# ALTERATION OF TERRAIN AMENDMENT REQUEST FORM

8. PLAN CHANGE - ENTER ONLY IF REQUESTING A PLAN CHANGE

**PROJECT NARRATIVE****Alteration of Terrain Amendment Request***AoT Permit #AoT-1072***Pike Brook Road, New London, NH****Project Location: Tax Map 135, Lots 10 and 11 & 136, Lot 7**

# PIKE BROOK ROAD RE-ALIGNMENT ~ STA 0+16 to 9+58

**D7**

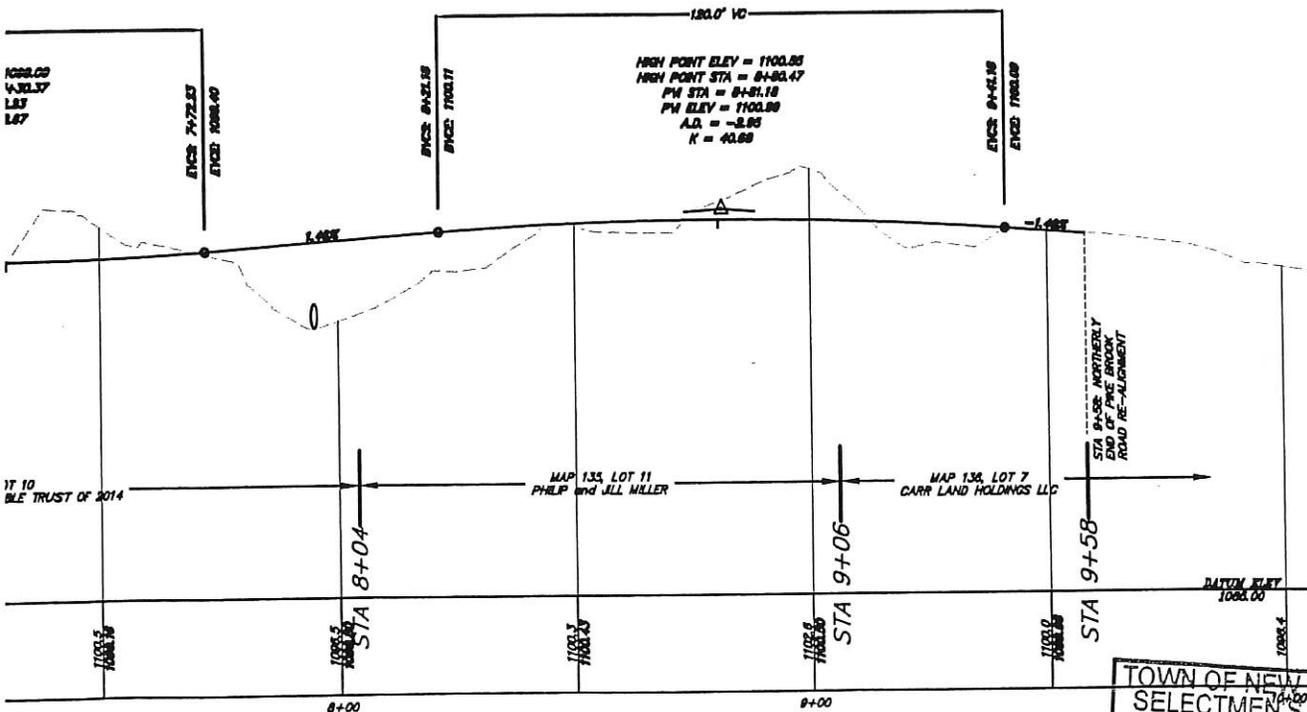
6. Summary of Plan Change. Within the space provided below, please summarize the plan changes. **DO NOT** write, "See Attached". This amendment proposes to re-align Pike Brook Road northerly from a point (STA 6+01) within Map 135, Lot 10 (Pike Brook Road Revocable Trust of 2014 - the current permit holder), through Map 135, Lot 11 (Philip Miller) and terminating at a point (STA 9+58) within Map 136, Lot 7 (Carr Land Holdings LLC). This re-alignment will shift the road up to 80' further away from the shoreline of Lake Sunapee. Existing driveways will be extended to the new road surface and existing road surfaces to be abandoned will be restored as shown on the plans. It is intended that Philip and Jill Miller will be added as the Permit Holder for the road and stormwater improvements on Map 135, Lot 11 and Map 136, Lot 6.

This amendment proposes to re-align the northern end of this section of Pike Brook Road – a total of 357 LF across the three properties. All three properties front on Lake Sunapee and the re-alignment will move the road approximately 80’ further away from the lakeshore. A separate amendment proposes to re-align the southern end of Pike Brook Road – a total of 406 LF across three properties - that will move the road at that end approximately 70’ away from the lake. All properties involved with these amendments include restoration of abandoned roadbed and the extension of existing driveways to the new road. The work proposed by this Amendment can be found on new project plans D7, D9, D10 and D11 (note: Sheet D8 is a plan of work for the 406 LF of roadwork that will be submitted with the Amendment at the southern end of Pike Brook Road).
